# UNITED STATES PATENT AND TRADEMARK OFFICE

APPLICATION NO.	FILING DATE	FIRST NAMED INVENTOR	ATTORNEY DOCKET NO.	CONFIRMATION NO.
10/070,501	03/07/2002	Vladimir Kliatzkin	P-2684-US	7024
27130	7590	06/17/2004	EXAMINER	
EITAN, PEARL, LATZER & COHEN ZEDEK LLP 10 ROCKEFELLER PLAZA, SUITE 1001 NEW YORK, NY 10020			ALEJANDRO, RAYMOND	
			ART UNIT	PAPER NUMBER
			1745

**Office Action Summary**

## **DETAILED ACTION**

**FIG. 18**

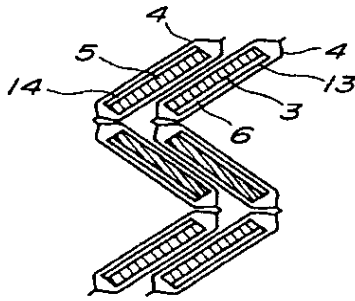
Honda et al disclose a rectangular battery including a plurality of cathode plates and anode plates alternately superposed via a separator to face each other. The cathode plates and the anode plates are consecutively packed with the separator and being folded at a separator fusing portion between the plates (ABSTRACT). It is disclosed that the anode plate is formed by a copper foil having both or one side thereof coated with a mixed anode agent; the separator is composed of a polymeric material and the rectangular battery has at least the cathode plates or the anode plates respectively packed with the separator, intrusion of the powder of the cathode plate and the anode plate into each other is prevented (COL 2, lines 25-38). It is disclosed that the layered product formed by the electrode plates and the separator is inserted into a rectangular battery casing and then a liquid electrolyte is filled therein (COL 1, lines 15-20). It is disclosed the electrode are enveloped by or packed between the separators and the packed electrode plates being folded at the separator fusing portion (COL 1, lines 60-67).

Figures 18 and 20 below illustrate battery embodiments

**Examiner's note:** the claim language "means being provided for maintaining pressure from granule to granule and from granule to electrode flexible frame for needed electrical contact)" has not been construed as invoking the 35 USC 112, 6<sup>th</sup> paragraph because it does not meet, at least, two of the 3-prong analysis conditions due to the over-modified structure for achieving the specified function (See MPEP 2181). That is, a) the claim limitations does not strictly use the phrase "means for" (i.e. the claim recites "means being provided for") and b) the phrase "means for" must not be modified by sufficient structure, material or acts for achieving the specified function as instantly claimed.
